Access Compliance Report Public Rights-of-Way (Curb Ramps)

Main Street: CEDARWOOD_AVE Cross Street: LEDON_WAY Location: NE

ADA ID: RPRK211005174538 Ramp Type: Type 1 - Perpendicular Diagonal Initial Pass/Fail: Fail Overall Compliance: No Severity Score: 16

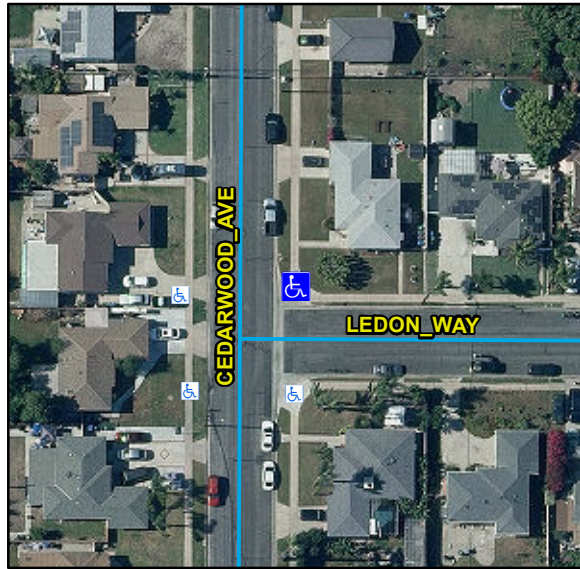
Compliance	Description	Data	Compliance	Description	Data
N/A	Ramp Length (in)	96	N/A	Flare Type LT	
Yes	Ramp Width (in)	48			N/A
No	Ramp Run Slope (%)	11.2	N/A	Flare Slope LT (%)	N/A
No	Ramp Cross Slope (%)	3.5	N/A	Flare Traversable LT	N/A
N/A	Landing Present	N/A	N/A	Flare Type RT	
N/A	Landing Length (in)	N/A			N/A
N/A	Landing Width (in)	N/A	N/A	Flare Slope RT (%)	N/A
N/A	Landing Run Slope (%)	N/A	N/A	Flare Traversable RT	N/A
N/A	Landing Cross Slope (%)	N/A	N/A	DWS Provided	N/A
N/A	Landing Movement Obstructed?	N/A	N/A	DWS Contrast	N/A
	Landing Movement Type	N/A	N/A	DWS Length (in)	N/A
N/A	Landing Shared	N/A	N/A	DWS Full Width	N/A
N/A	Clear Space	Yes	N/A	DWS Offset Left (in)	N/A
N/A	Clear Space To Crosswalk (in)	N/A	N/A	DWS Offset Right (in)	N/A
N/A	Marked Crosswalk 1	No	N/A	Marked Crosswalk 2	No
	Crossing 1 Direction	W		Crossing 2 Direction	S
	Marked Crosswalk 1 Width (in)	N/A		Marked Crosswalk 2 Width (in)	N/A

Remove & Replace Curb Ramp With Two New Directional Ramps or Equivalent.
